RENESAS TECHNICAL UPDATE

Product Category	MPU/MCU		Document No.	TN-RX*-A073A/E	Rev.	1.00
Title	Corrections of 'RX21A Group User's Manual: Hardware Rev.1.00'		Information Category	Technical Notification		
Applicable Product	RX21A Group	Lot No.	Reference Document	RX21A Group User's Manual: Hardware Rev.1.00 (R01UH0251EJ0100)		
		All

This document describes the corrections in RX21A Group User's Manual: Hardware Rev.1.00. Changes are underlined in the list below.

Add a note which refers the write protection bit to the following registers' description: LVD1CR1, LVD1SR, LVD2CR1, LVD2SR, LVCMPCR, LVDLVLR, LVD1CR0, LVD2CR0.

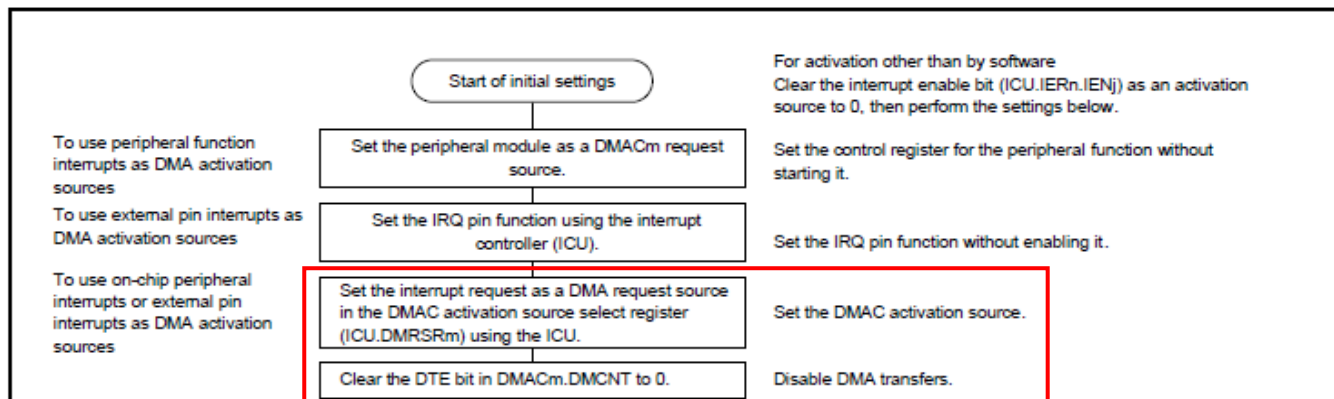
- Page 143 to 151

Note. Set the PRCR.PRC3 bit to 1 (write enabled) before rewriting this register.

Figure 20.6 I/O Port Configuration (6)

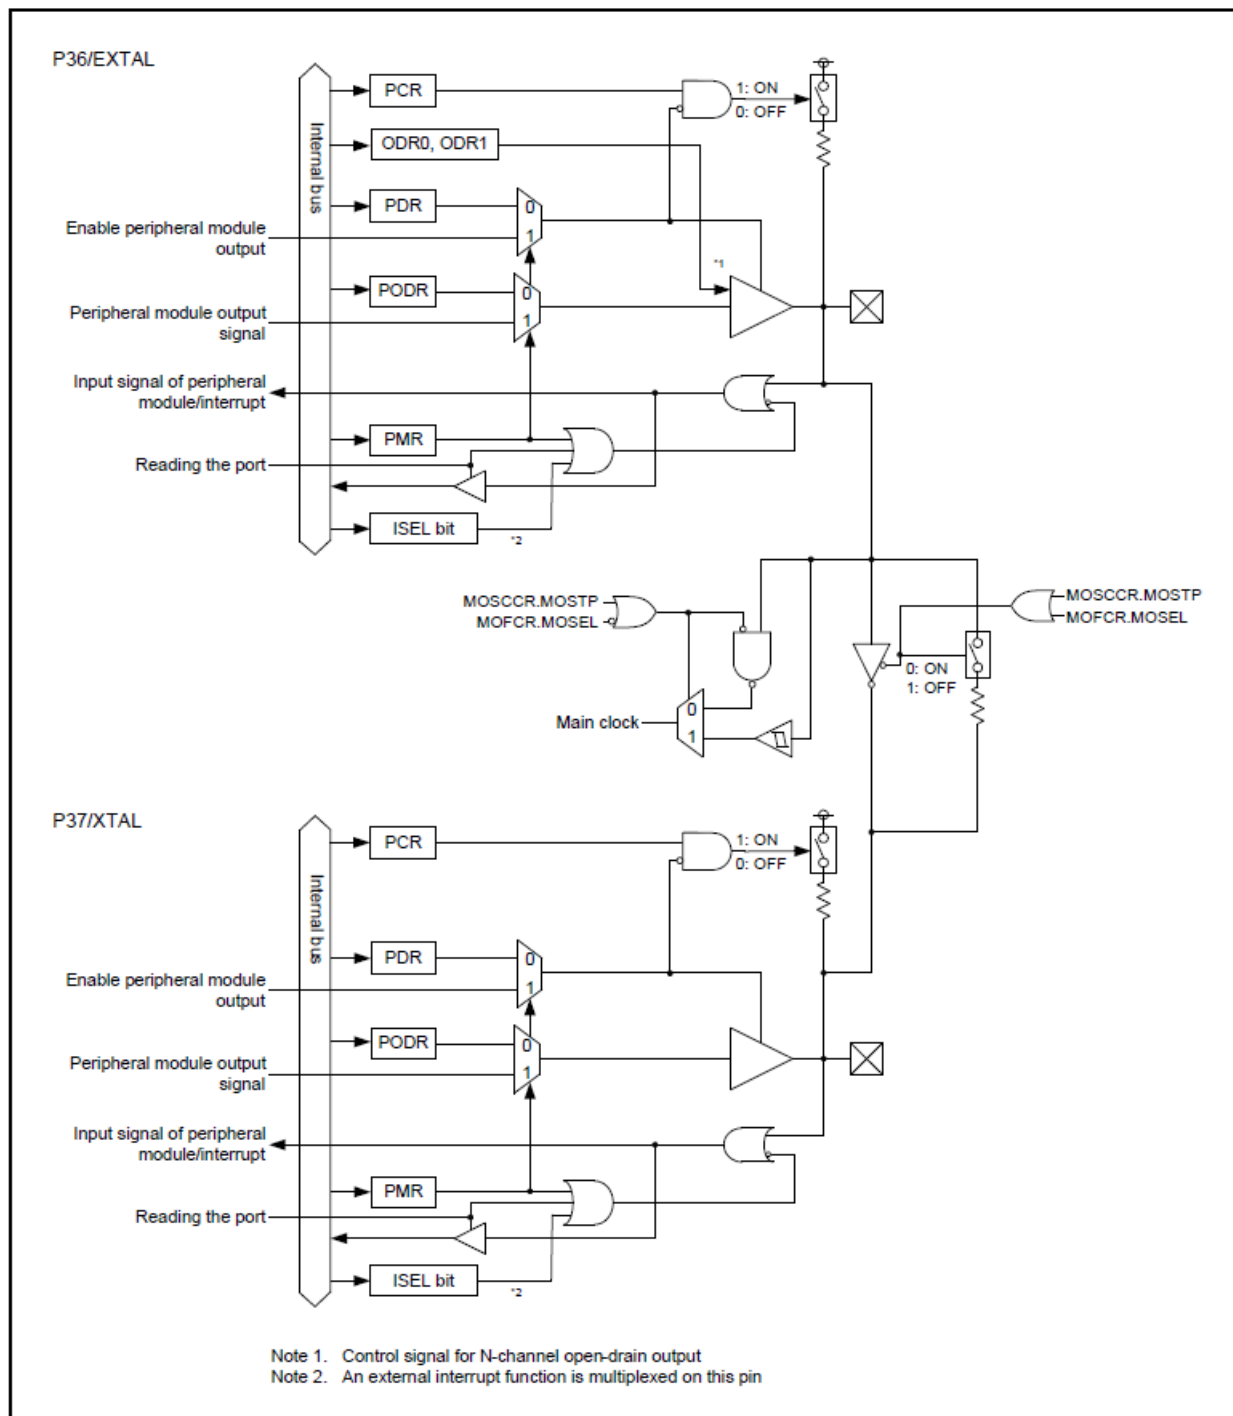
- Page 433

Add 'Figure 20.6 I/O Port Configuration (6)' next to Figure 20.5.

Correct the waveform of TRS in 'Figure 31.13 Master Receive Operation Timing (3) (when RDRFS = 0)'.

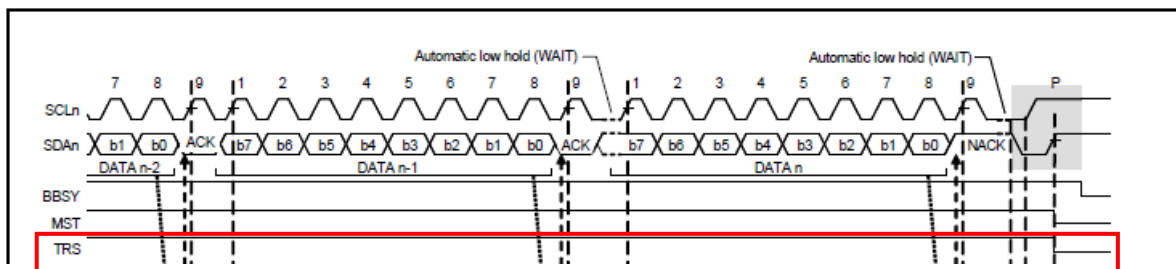
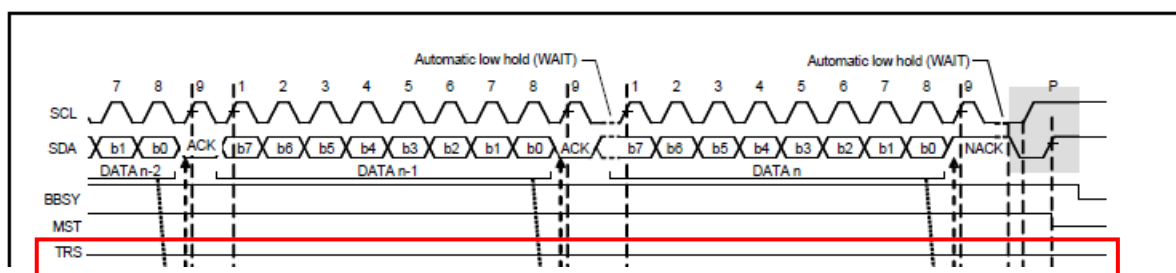
- Page 943

Correction

Add a description in '32.2.5 RSPI Data Register (SPDR)'.

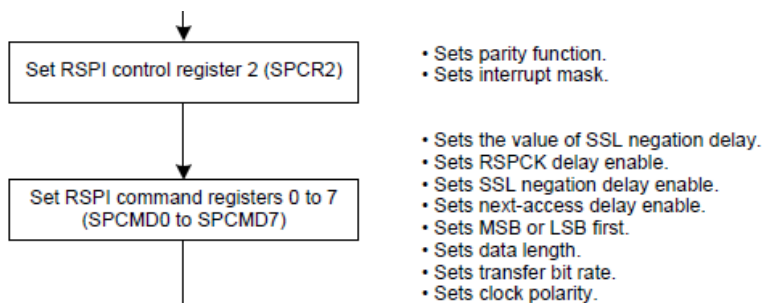
- Page 990

SPDR can be written to write a value to a transmit buffer (SPTXn). This is not influenced by the value of the SPDCR.SPRDTD bit unlike when reading the SPDR register.

The transmit buffer includes a transmit buffer write pointer which is automatically updated to indicate the next stage each time data is written to SPDR.

Add a step in 'Figure 32.34 Example of Initialization Flowchart in Master Mode (SPI Operation)' and 'Figure 32.45 Example of Initialization Flowchart in Master Mode (Clock Synchronous Operation)'.

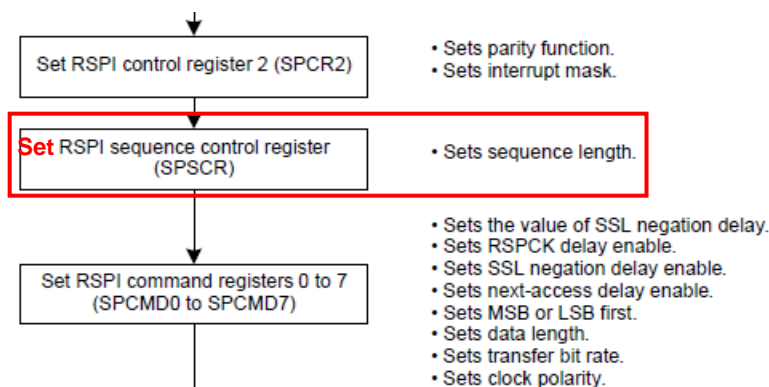
- Page 1039 and 1050

Corrected flow
